Cumalum Precinct A – Contributions Plan and DCP Provisions

Ordinary Council Meeting

Attachment 1 – Submissions

Subject : Cumalun Precinct A Development Control Plan

## B Proposed amendments to Council DCP Maps

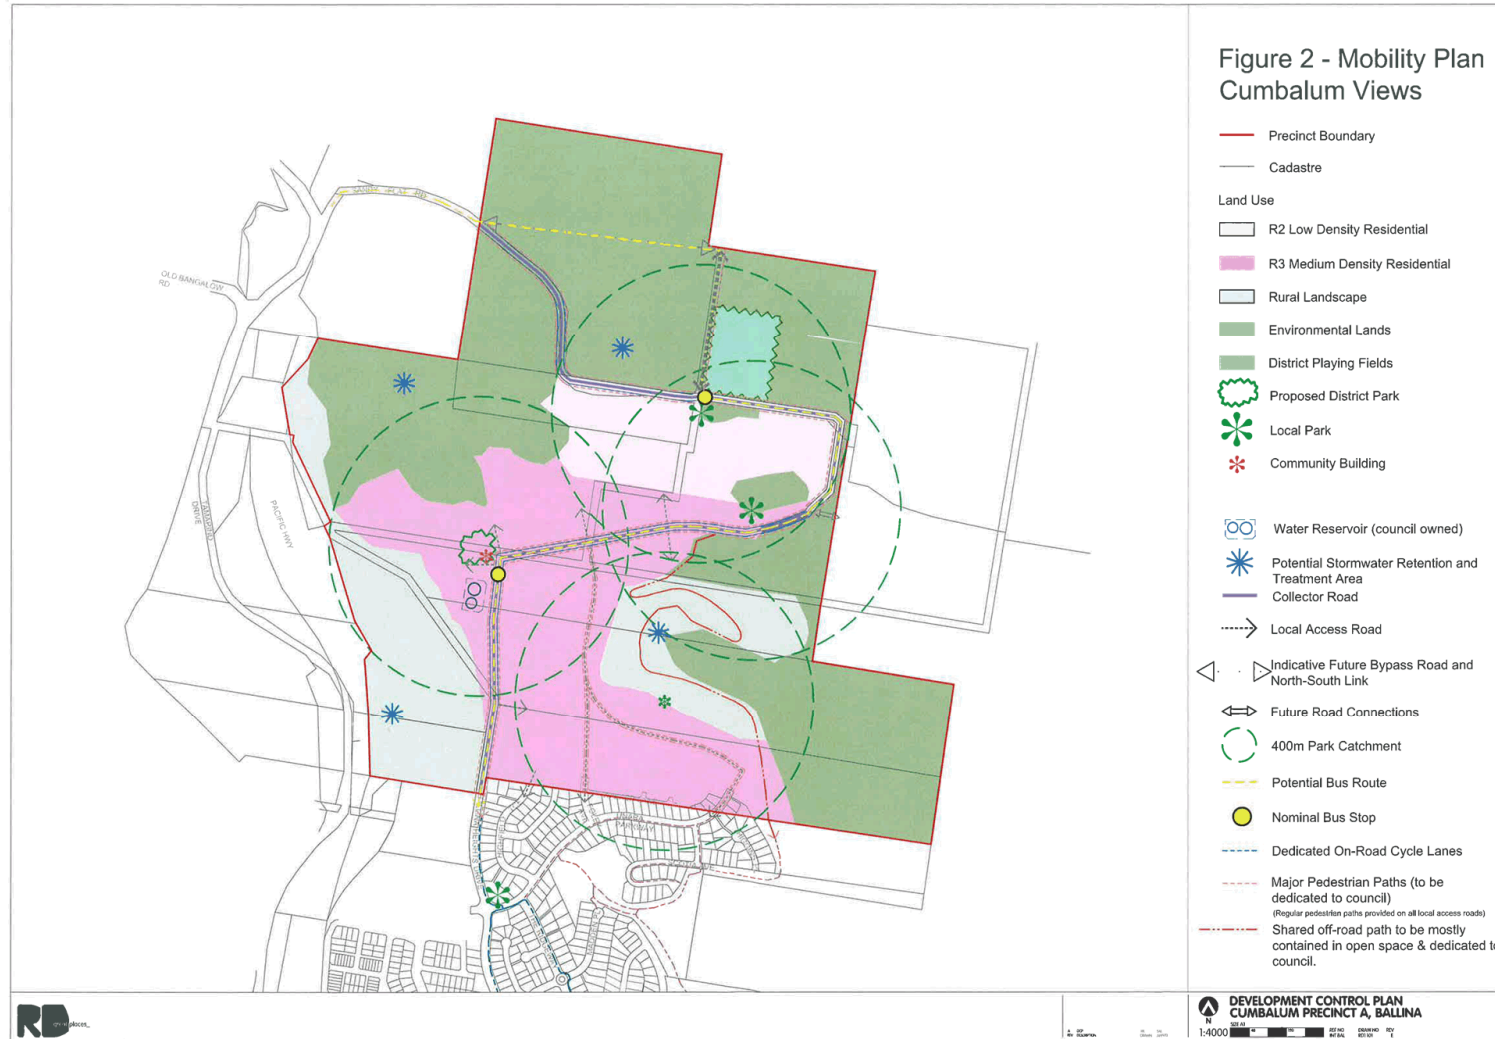
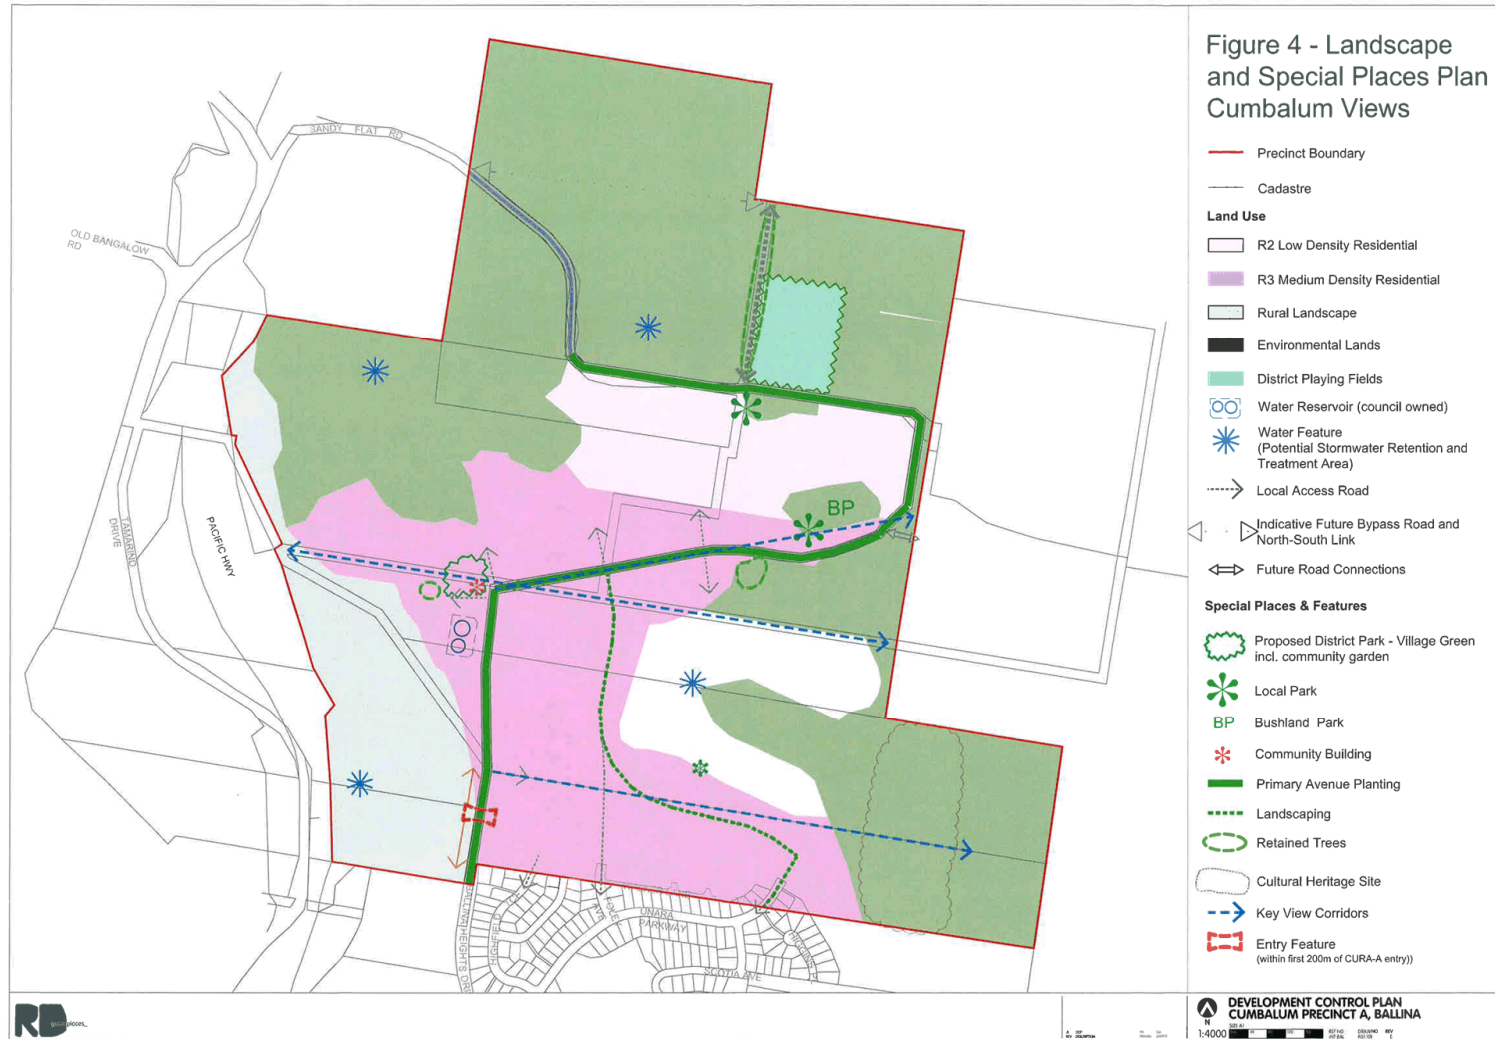
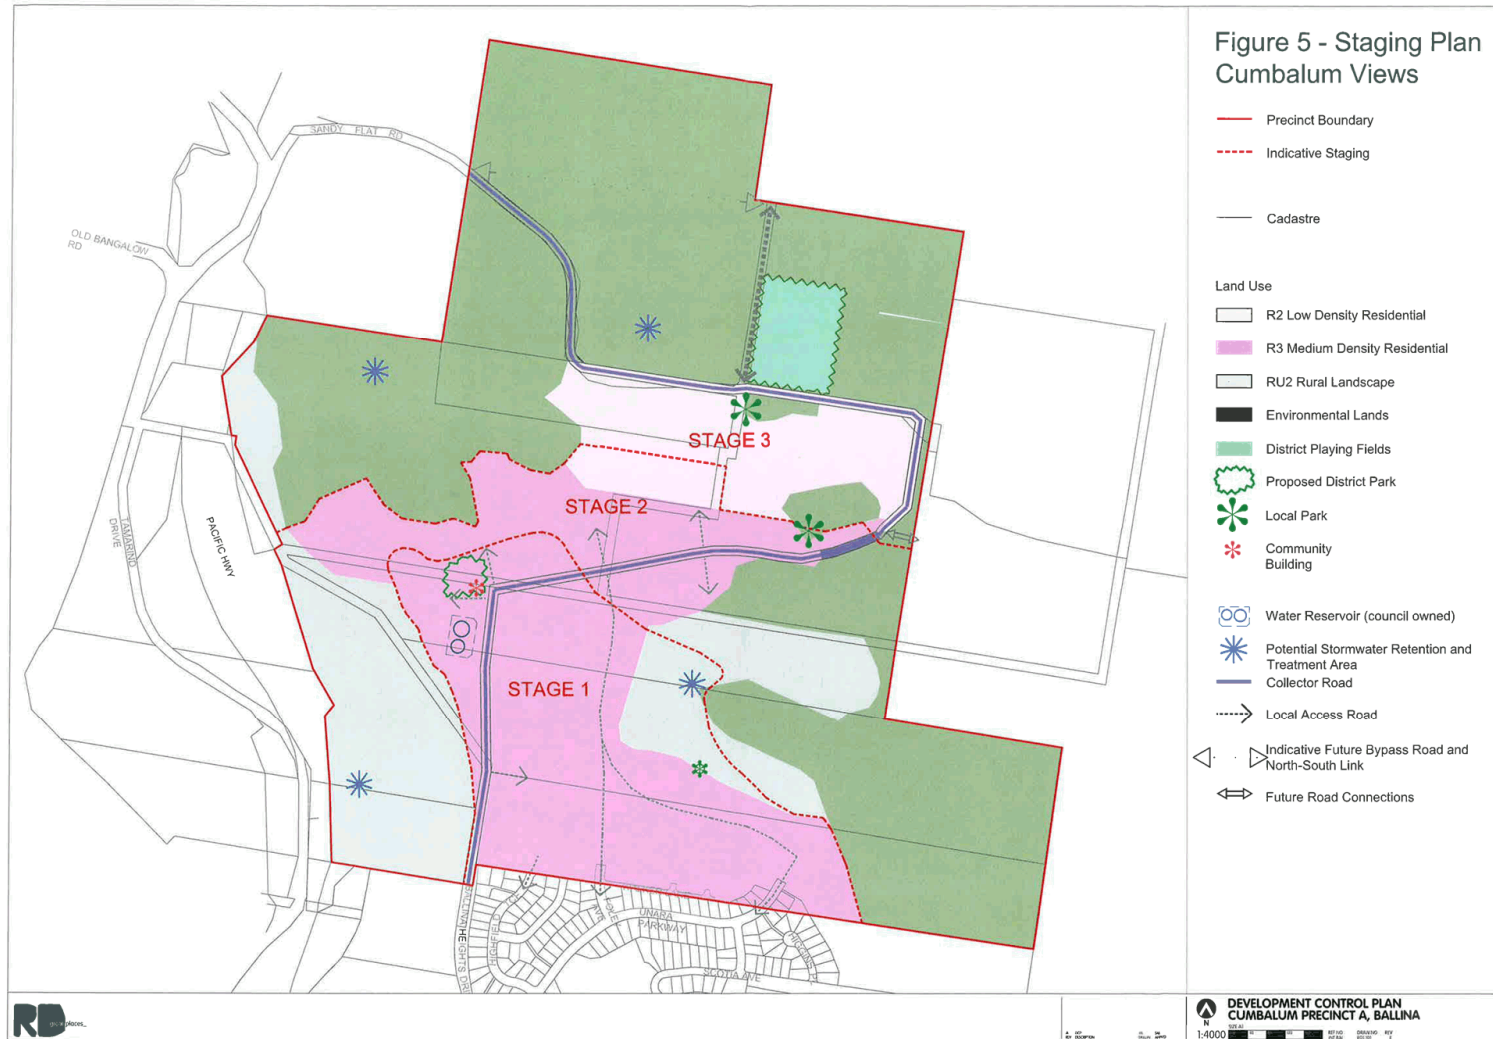
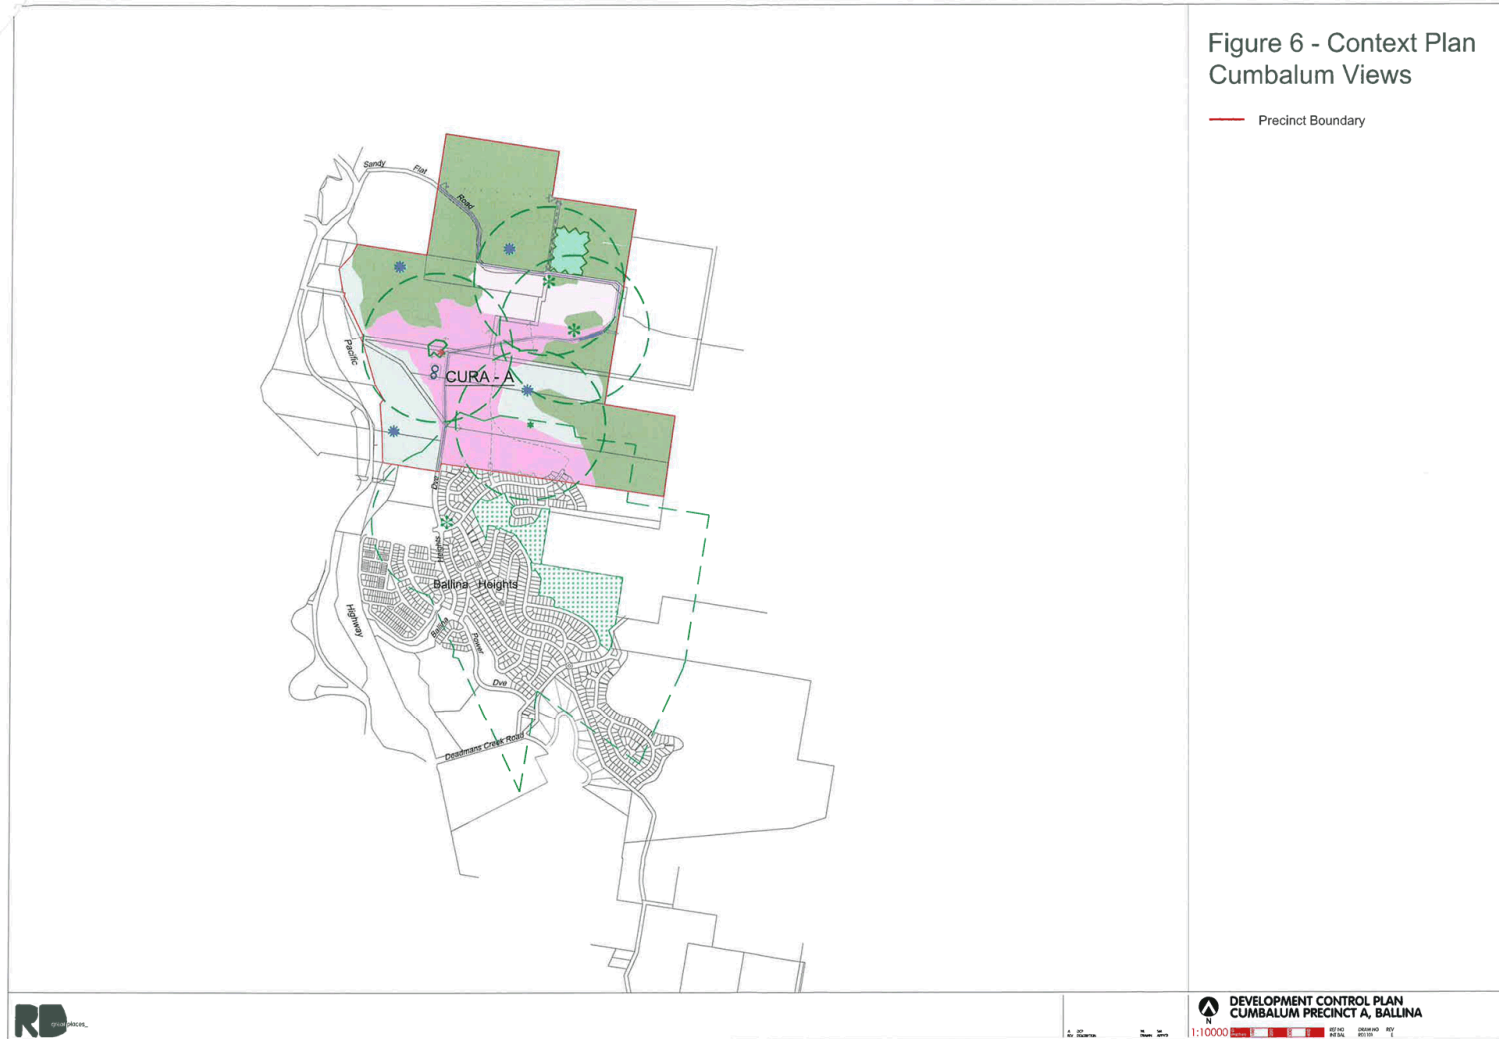
- » Section 5.6.3Dvii – this draft control refers to 'key site features', however it is unclear as to what these features include. The *Landscape and Special Places Plan Cumalun Views* (Figure 4) should be amended to clarify these features as demonstrated in the Plan attached (Annexure A1).
- » Section 5.6.3Bviii – these provisions are not clearly indicated on the Mobility Plan. The traffic calming measures should be in line with page 72 of the Council report of its meeting on 27 November 2014. It is requested that Council amend the Mobility Plan to reflect their report.

A      The Ridge Parkland

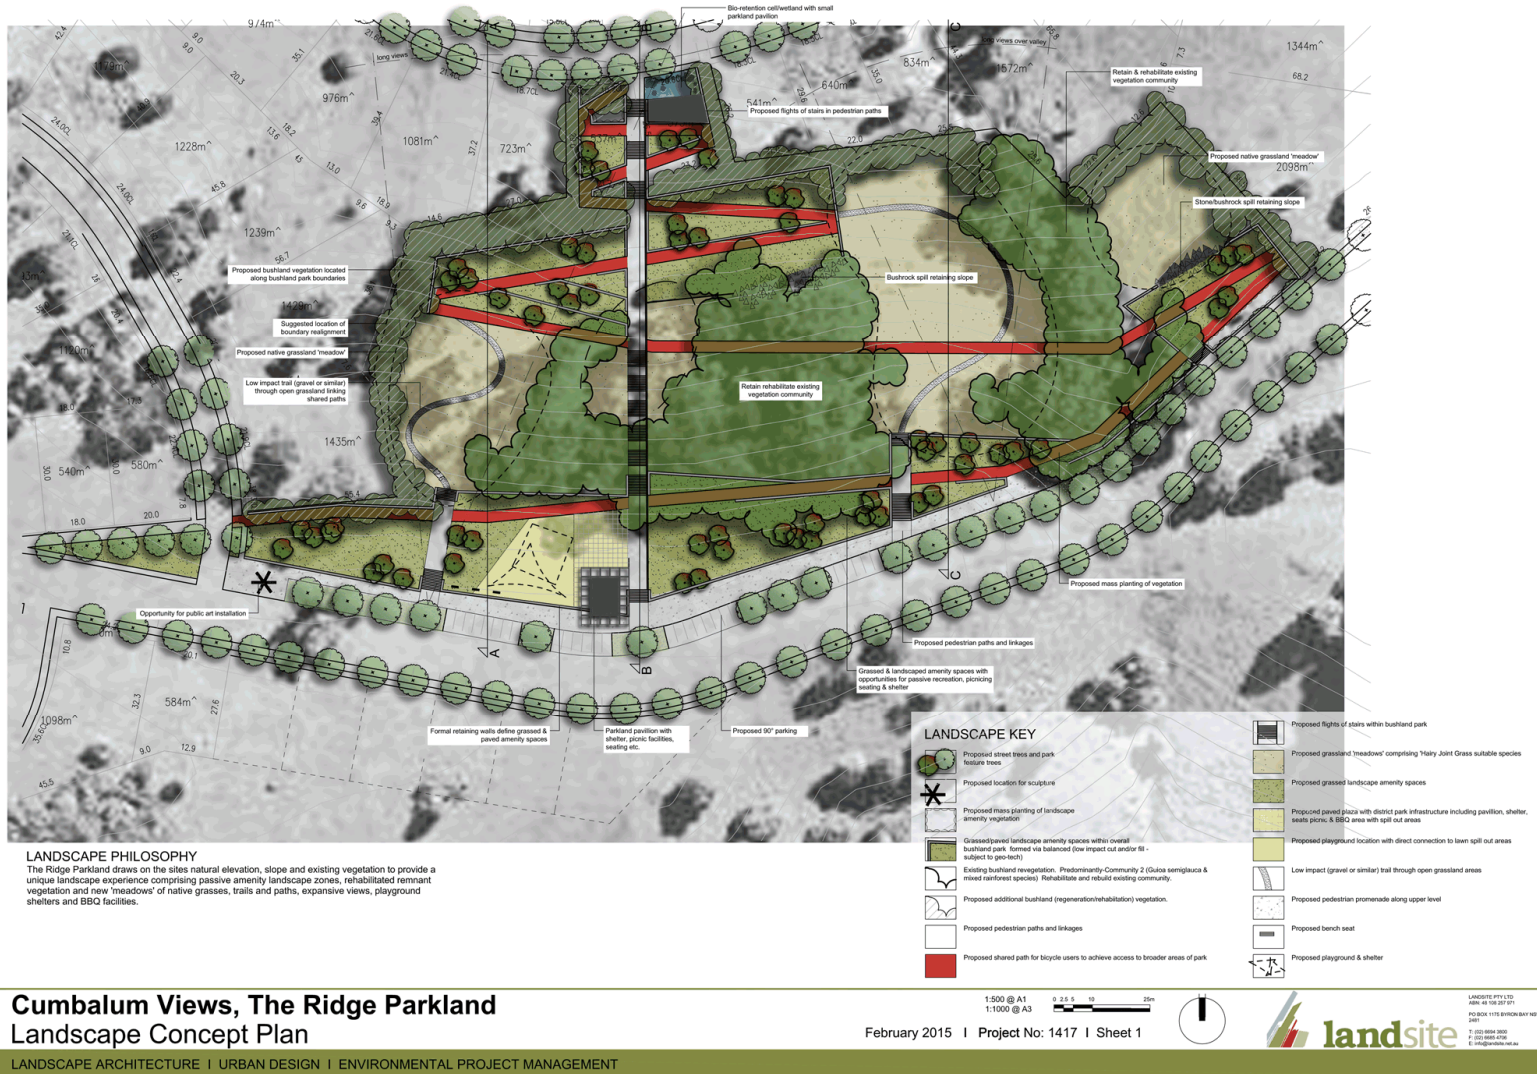
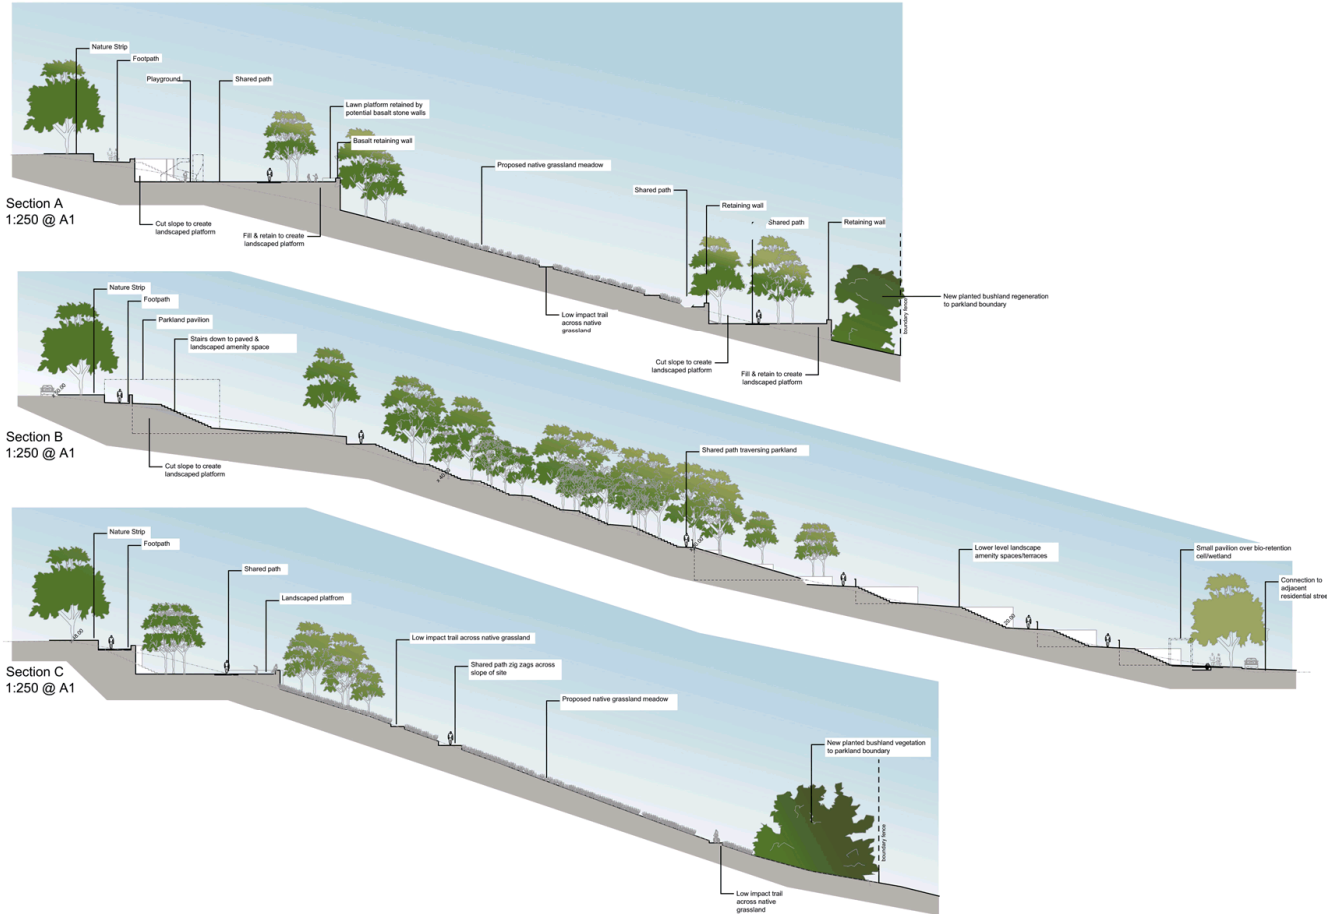
That the draft DCP be amended to include The Ridge Parkland open space as a key and integrated park within the DCP.
